MEMORANDUM

SUBJECT: Site Plan Approval – VL Main Avenue, 144 Main Avenue, 160 Main Avenue, 160 Rear Main Avenue, 164 Main Avenue and 202 Main Avenue, Parcel Numbers 2-01-332.002, 2-01-301.001, 2-01-301.000, 2-01-302.000, 2-01-332.003 and 2-01-332.004

DATE: July 27, 2023

Request: Site Plan Approval to construct a 15,900 SF, 61-unit, four-story apartment building at **VL Main Avenue, 144 Main Avenue, 160 Main Avenue, 160 Rear Main Avenue, 164 Main Avenue and 202 Main Avenue**, Parcel Numbers 2-01-332.002, 2-01-301.001, 2-01-301.000, 2-01-302.000, 2-01-332.003 and 2-01-332.004

1 SITE PLAN
C201 SCALE: 1" = 20'

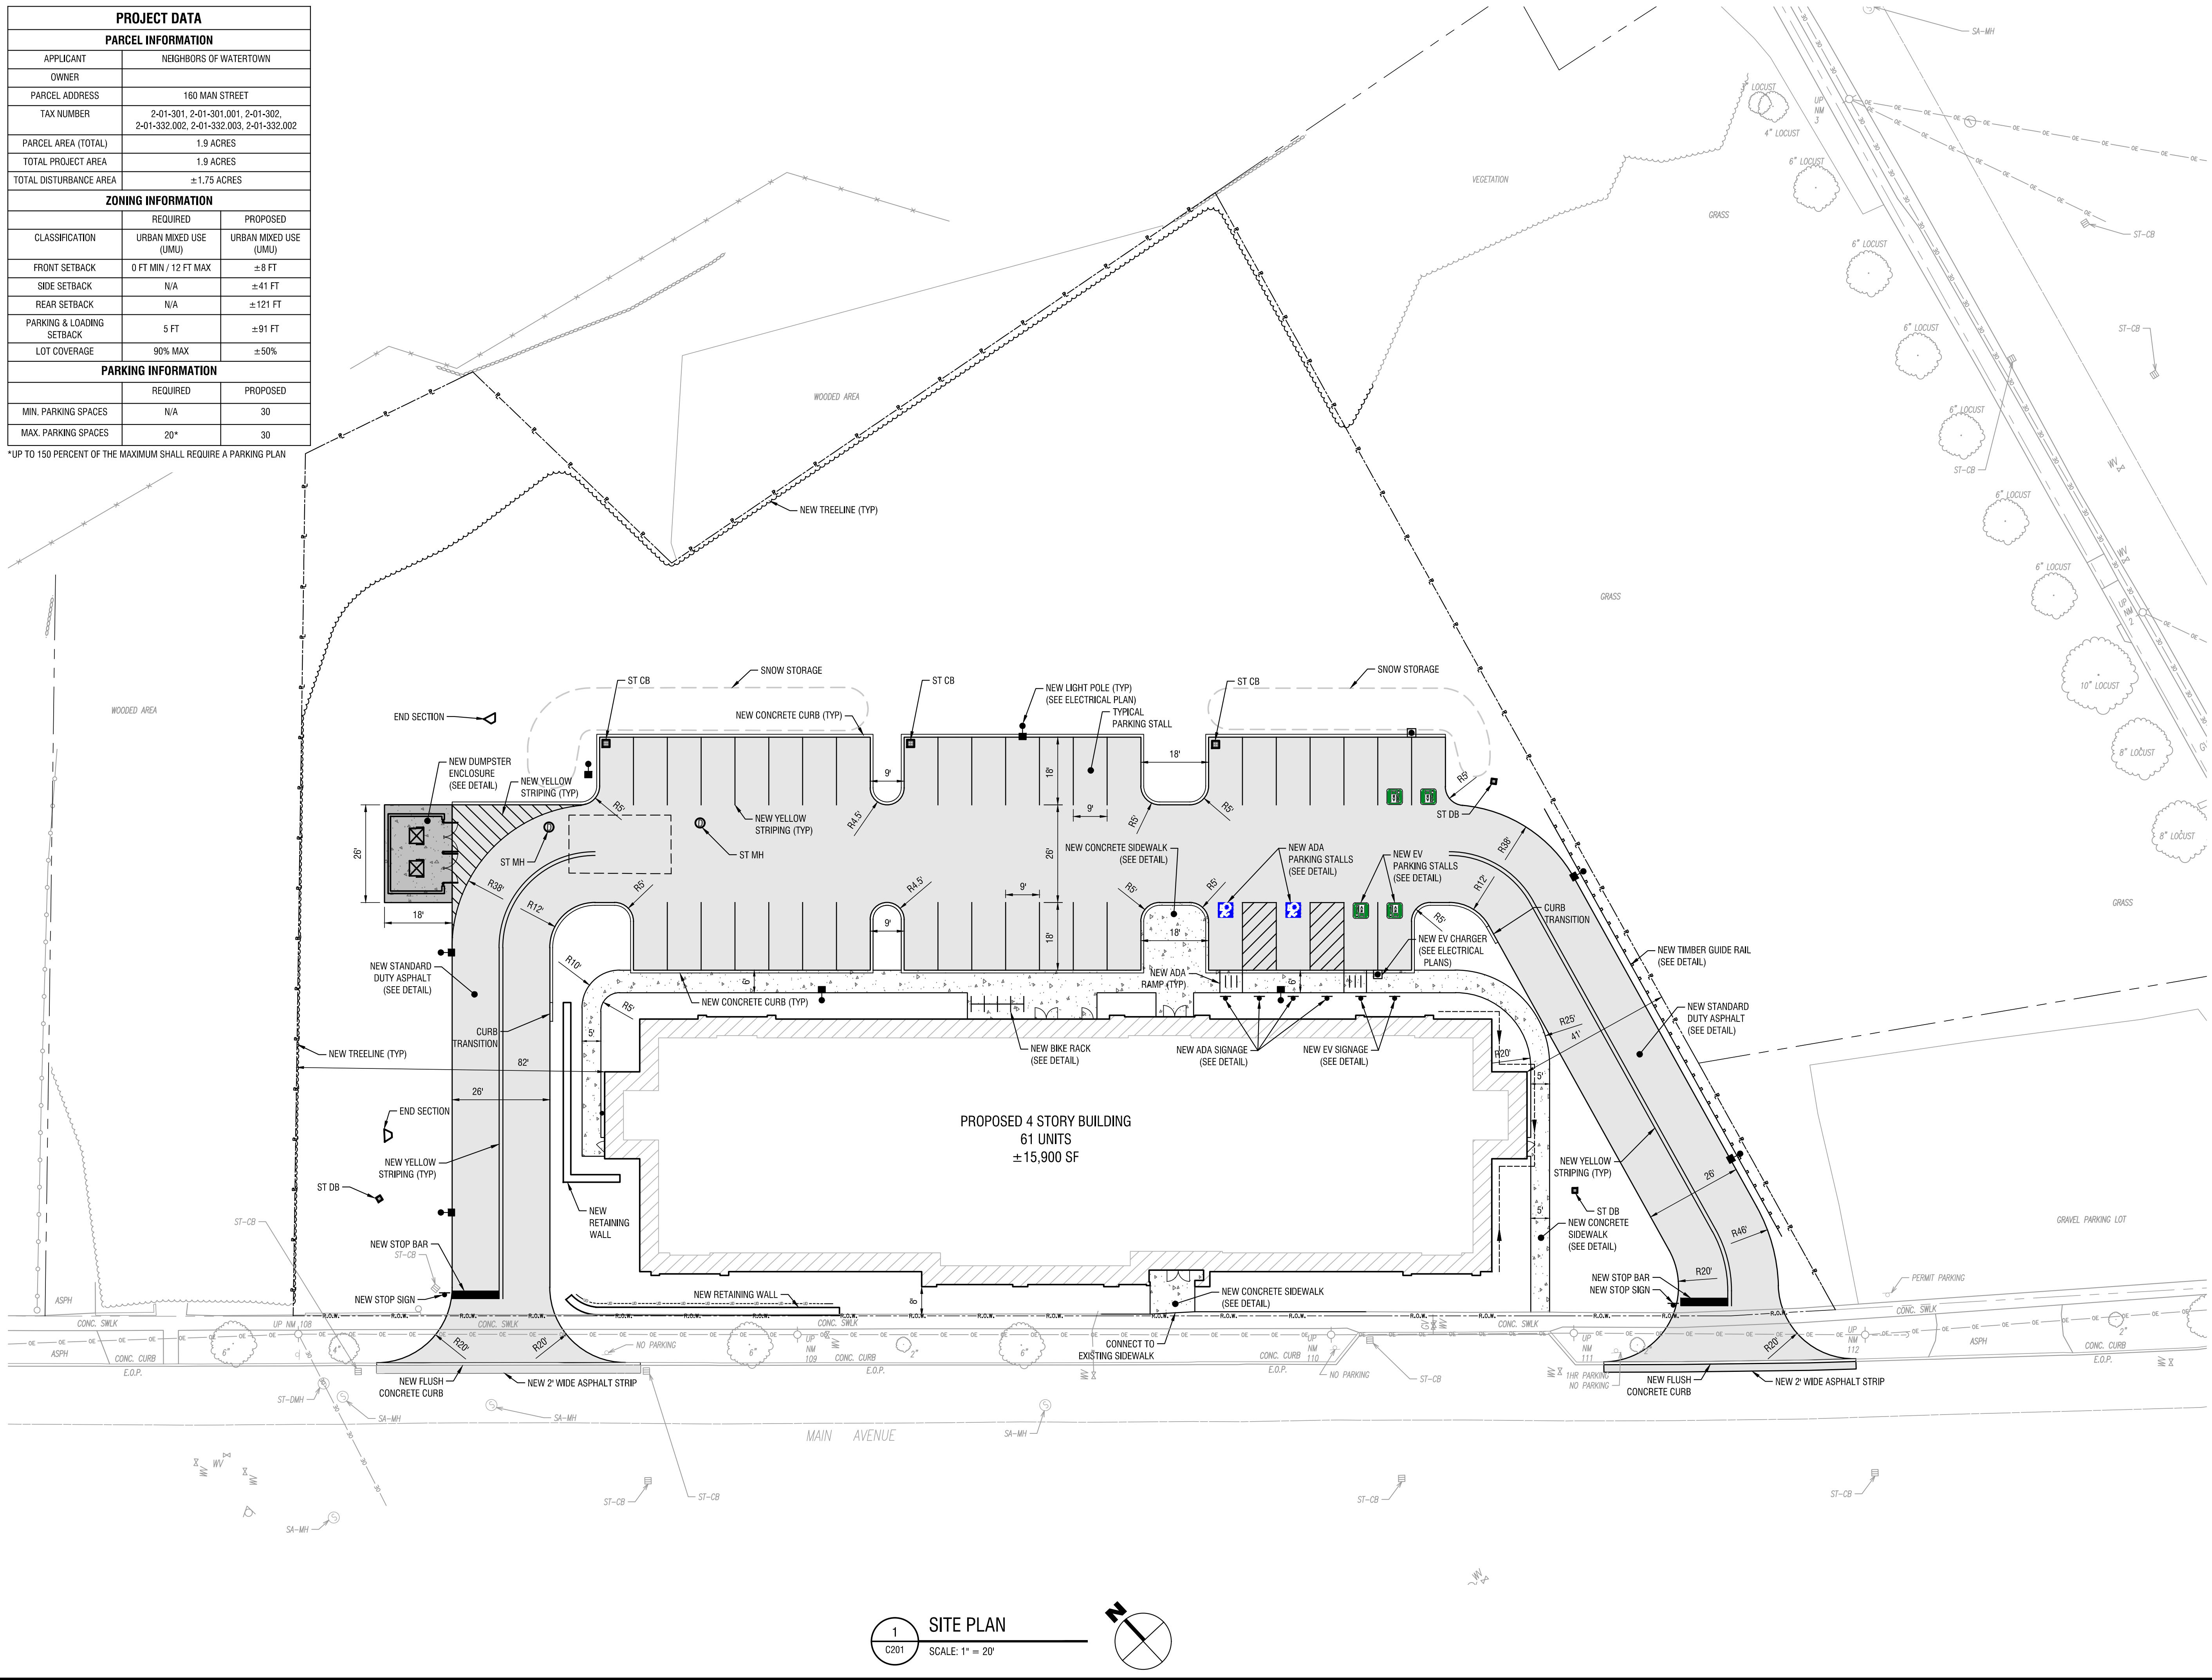
Parking: The Urban Mixed-Use District allows a maximum of 20 parking spaces; however, the applicant is proposing 40 spaces. Section 310-36 (E)(3) of the Zoning Ordinance states that:

While the number of proposed spaces is 200% over the maximum allowed in the Zoning Ordinance, the Transportation Demand Management Plan provided in the application adequately demonstrates that the additional parking will not have a negative impact on the surrounding transportation network or be excessive for the proposed use.

LIGHTING PLAN

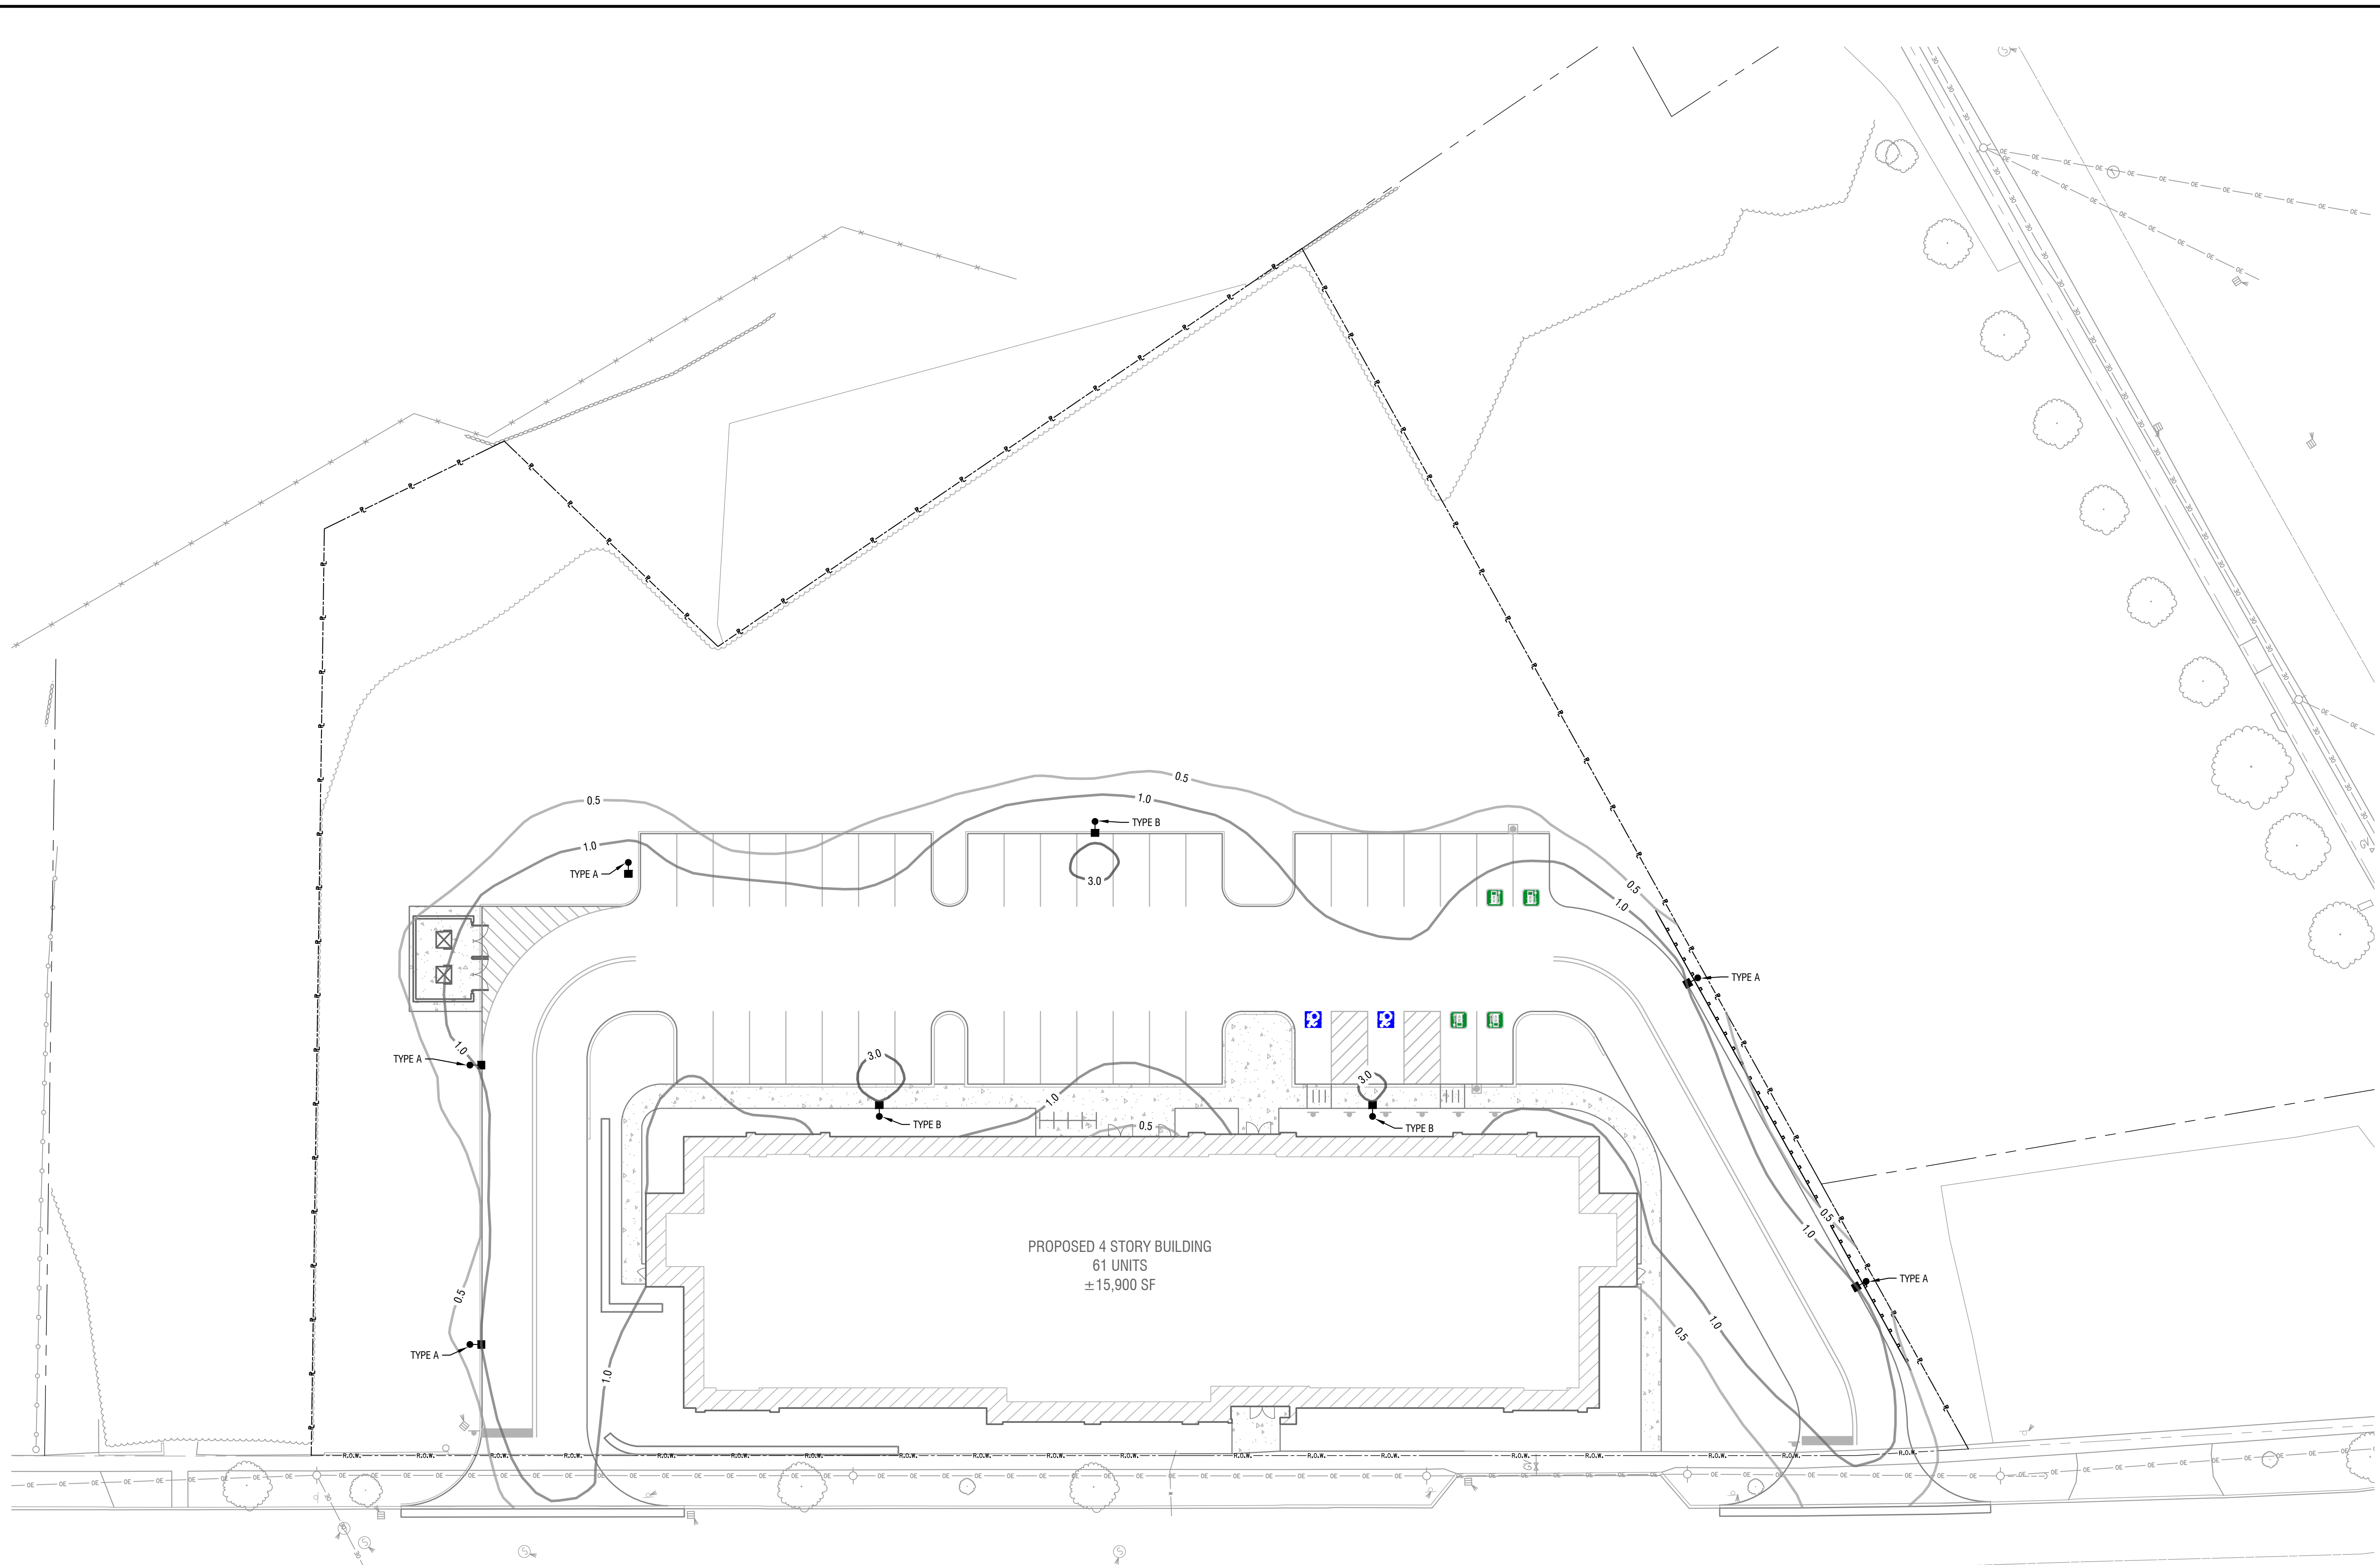
Lighting: The applicant submitted a Photometric Plan, consistent with Section 310-84 of the Zoning Ordinance, which requires that light trespass not exceed 0.5 footcandles at the property line. The plan submitted shows light poles along the entrance drives, within the parking lot and near the rear entrance. There is no lighting shown near the front or side entrances, which could be a safety issue for residents

3. The applicant shall consider the addition of lighting to the entrances to the building along the front and side for pedestrian safety.
4. To avoid future damage to the trees, the applicant should amend the planting plan to relocate trees from the proposed snow storage areas.
